Prepared by: EOR

For the Green Lake Association, Green Lake Conservancy, and Green Lake Sanitary District

Hydrologic Evaluation of the Proposed Skunk Hollow Mine, Green Lake County, Wisconsin

Figure 2. Water table elevation contours and generalized groundwater flow direction. From [USGS, 1995](#). Location notation added by EOR. Note drop in water table from mine site toward Green Lake.

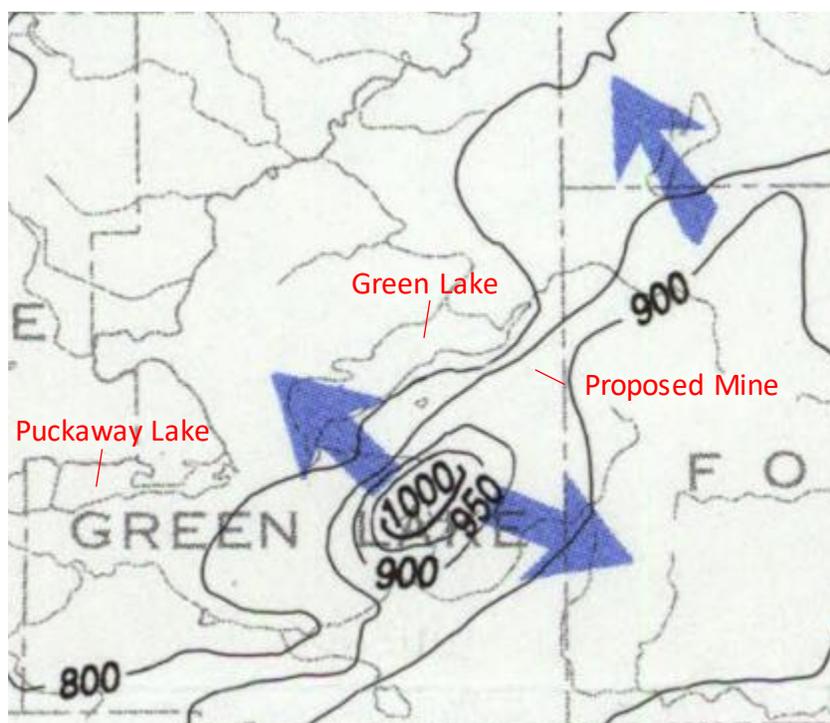
It is unlikely that the water table at the proposed mine site is as deep as estimated in the CUP application. An elevation of 918 ft is lower than Powell Spring. Available information indicates that groundwater flows from the area including the mine site toward Powell Spring, White Creek, Mitchell Glen, and Dakin Creek, which means that the water table at the mine site would be higher than the spring. Figure 1 illustrates a typical groundwater flow system, with the water table sloping downward toward streams and lakes. A statewide water table map from the US Geological Survey¹ (Figure 2) shows that the mine site is near a groundwater divide, with a water table slope to the northwest driving groundwater flow toward Green Lake. The water table elevation at the mine site therefore must be higher than the Powell Spring elevation of 923.4 ft, listed in the spring survey report by the WGNHS.

1. Mining should not occur below the water table due to the risk of mobilizing metals in groundwater. The current plan does not appear to meet this criterion.
2. The areas at highest risk of groundwater contamination from the mine are north and west of the mine site, including White Creek, Powell Spring and Creek, Mitchell Glen, Glen Creek, and Dakin Creek.
3. The potential risk of groundwater impacts on other properties should be evaluated through installation of monitoring wells to identify the groundwater flow direction(s). Because the mine site is located near a groundwater divide on the USGS water table map (Figure 2), groundwater flow in multiple directions from the mine site is possible.

Figure 3. Comparison of water level data and proposed quarry elevation. Static water level elevations estimated from selected Well Construction Reports are labeled in red. Note drop in water levels to the north and west toward Dakin Creek and White Creek.

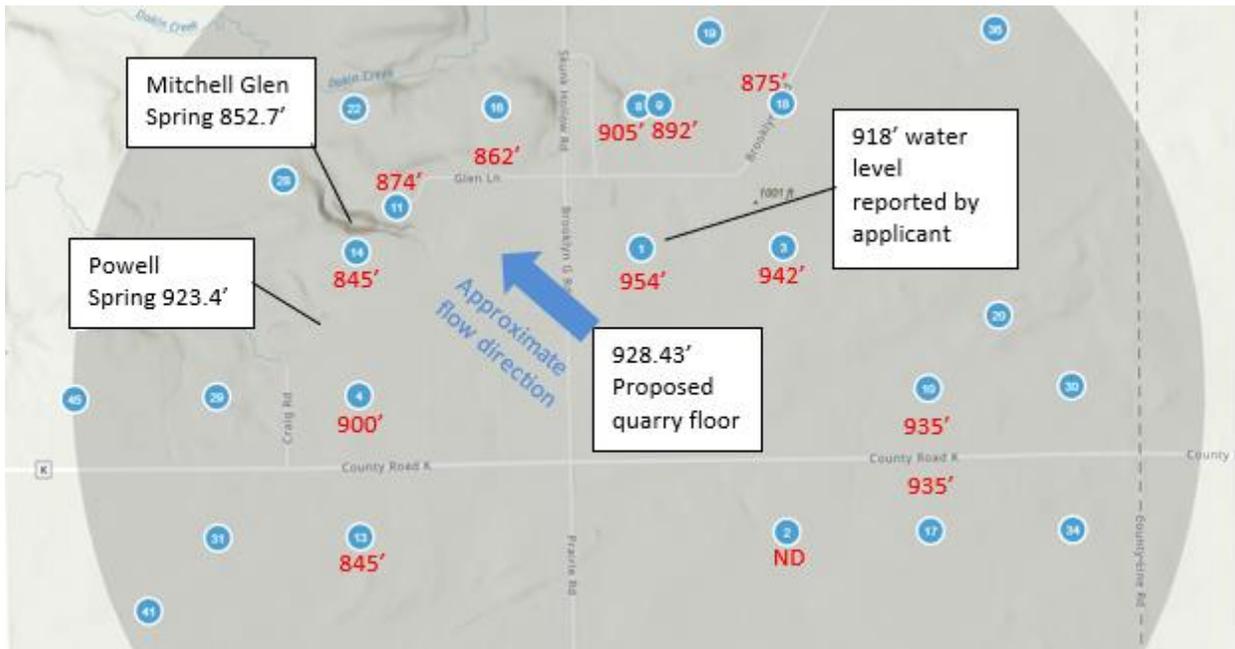
associated with each well record, where possible, and determining the ground surface elevation from topographic maps. Estimated water levels near the mine site (Figure 3) show that groundwater drops from the mine site to the north and west, toward Dakin Creek, White Creek, and Green Lake. Static water elevations estimated for the three WCRs closest to the mine site, south and east of Brooklyn G Rd. and north of CTH K, are 935 ft, 942 ft, and 954 ft. The latter well is on the Kinas property, and the CUP application reports an observed depth to water of 60 ft in January 2022, without describing measurement methods. The static depth to water reported on the WCR in 1976 was only 26 ft. The difference in water levels between this reported water level and the deeper measurement reported by Kinas may be related to errors in either or both measurements and/or groundwater level fluctuations over time.

1. Available information indicates that the water table at the mine site is higher than the proposed pit floor elevation.
2. Available data are not adequate to precisely determine the water table elevation at the site, and monitoring wells should be installed.
3. The water table elevation naturally fluctuates with wet and dry cycles, and it is likely that the water table elevation in the future will fluctuate above and below the level that is measured now.
